VALENCIA CORNER SUBDIVISION

Engineering Comments: FINAL PLAT COMMENTS (should be addressed prior to submitting the FINAL PLAT for acceptance and signature by the City Engineer):

APPLICATION NUMBER 6 DATE September 7, 2017

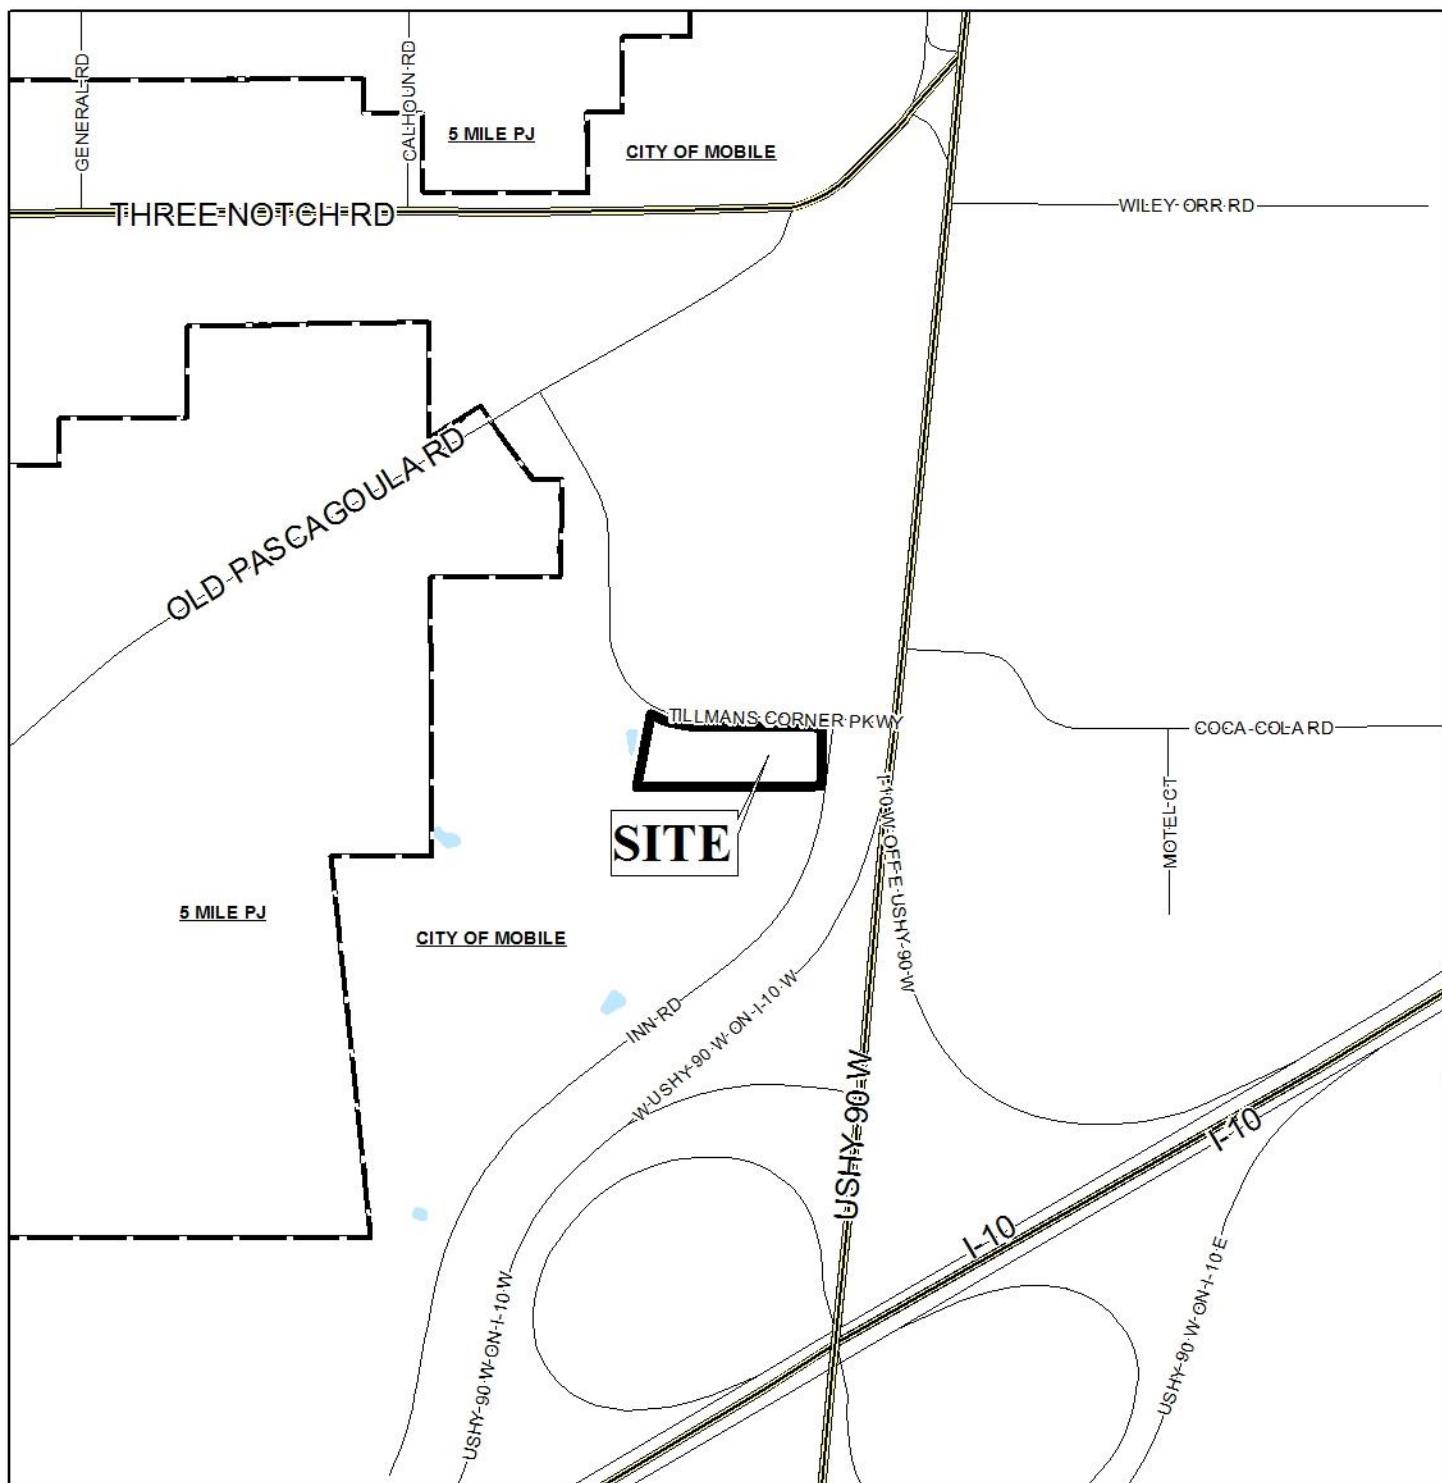
The submitted site plan depicts all parking spaces proposed for the development to be configured at a 90 degree orientation, specifically along the inbound and outbound areas, and do not reflect the required angled parking as indicated in the statement from ALDOT. However, there is only one access point proposed along Inn Road, and not two points of access. The applicant needs to ensure that ALDOT has been given the most recent site plan for review, or should make the necessary changes to the site plan in order to comply with ALDOT stipulations regarding the curb-cut along Inn Road, as well as complying with the City of Mobile's Zoning Ordinance requirements for commercial parking areas.

The 25-foot minimum building setback line is depicted on the preliminary plat along both Tillmans Corner Parkway and Inn Road, and should be retained on the Final Plat, if approved.

The proposed lot exceeds the 7,200 square foot minimum lot size requirements for lots served by public water and sanitary sewer systems. The lot size information is indicated in acres; however, the Final Plat, if approved, should also indicate the lot size information in square feet as well.

As a means of access management, a note should be placed on the Final Plat stating that the lot is limited to two curb-cuts to Tillmans Corner Parkway and one curb-cut to Inn Road, subject to approval from ALDOT, with any changes to the size, location and design to be approved by Traffic Engineering and ALDOT, and conform to AASHTO standards.

- 1) Retention of the right-of-way width along Tillmans Corner Parkway;
- 2) Revision of the right-of-way width along Inn Road to depict a width of 60';

- 3) Retention of the 25-foot minimum building setback line along both Inn Road and Tillmans Corner Parkway;
- 4) Revision of the lot size information to be depicted in both square feet and in acres;

- 5) Placement of a note on the Final Plat stating that the lot is limited to two curb cuts to Tillmans Corner Parkway and one curb-cut to Inn Road, subject to approval from ALDOT, with any changes to the size, location and design to be approved by Traffic Engineering and ALDOT, and conform to AASHTO standards.
